Proposal for amendments to UN Regulation No. 67 (LPG vehicles)

The text reproduced below was prepared by the experts from Germany. It proposes a new series of amendments to UN Regulation No. 67 to improve the specifications for the LPG-Multi-valve. The modifications to the current text of UN Regulation No. 67 are marked in bold for new characters and strikethrough for deleted characters.

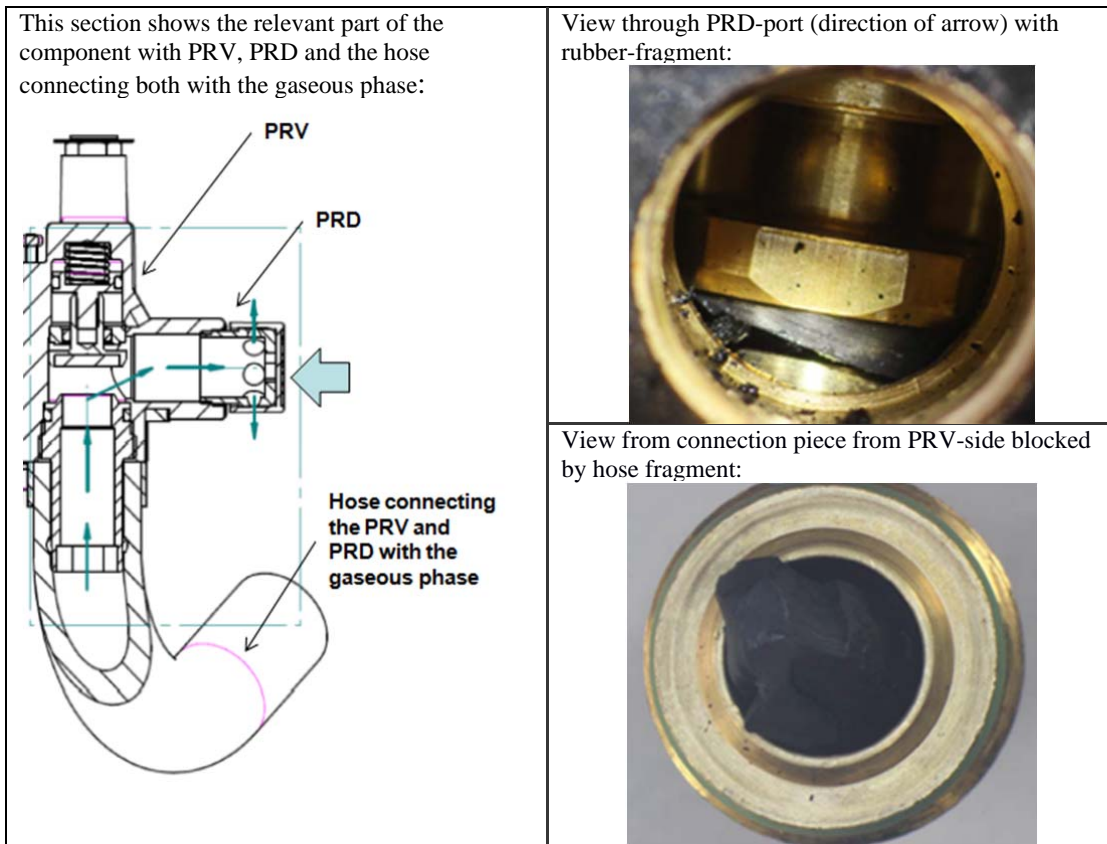
6.15.8.1. The pressure relief valve shall be mounted inside the container or on the container, in the area where the fuel is in gaseous state. **Any components connecting the pressure relief valve with the gaseous phase shall be made of metallic material.** "

"6.15.8.7. The pressure relief device shall be mounted on the container in the gaseous zone. **Any components connecting the pressure relief device with the gaseous phase shall be made of metallic material.** "
